AS-BUILTS

NOTES IN RED ARE PER FIELD DISCUSSIONS AND AGREEMENTS ON 03/01/04 BETWEEN CITY AND CONTRACTOR

DRAWN BY: KK	CITY OF WEST LINN ENGINEERING DIVISION	TOMPKINS STREET IMPROVEMENT SANITARY SEWER AND STORM DRAINAGE PLAN & PROFILE	SURVEYED BY: SR, KK CHECKED BY: STAFF DESIGNED BY: KK
SCALE: AS NOTED DATE: 10-7-03			PROJECT NO.: DRAWING FILE: REV. PLAN & PROFILE OPT. B
FILE: TOMPKINS SD/SS			PS2

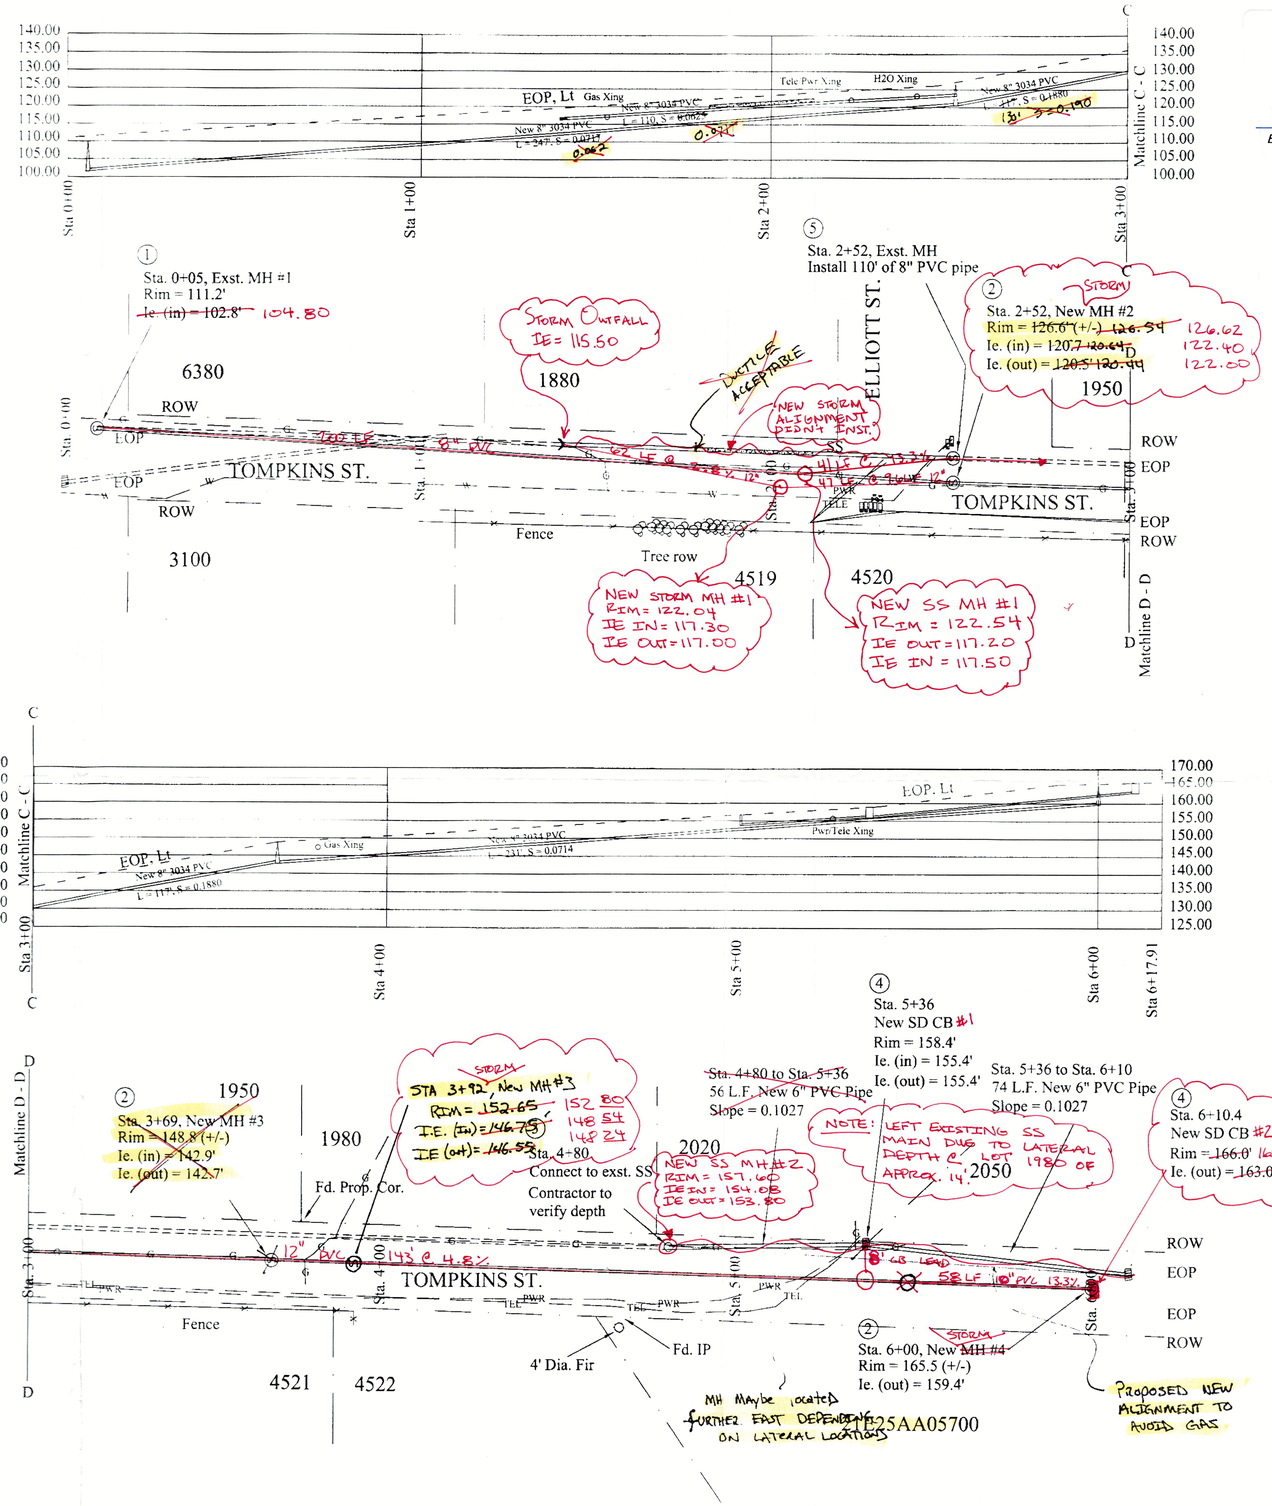
STATION	DIRECTION LOCATED	DISTANCE	ELEV.
2+52	N	12'	126.255
3+92	S	8'	152.46
6+00	W	8'	165.895

Kevin - For the file. Still awaiting word from Rod. Thanks Glenn

2+04	39"	(Tele, Phone, Pwr)
2+36	38" - 42"	(Tele, Phone, Pwr)
2+74	25" - 31"	(Phone, Pwr)
2+94	57"	(Gas)
3+59	25" - 31"	(Phone, Pwr)
4+35	30"	(Gas)
4+52	24" - 40"	(Gas)
5+30	24" - 40"	(Tele, Phone, Pwr, Water)
5+31	33"	(Gas)
5+44	36"	(Gas)
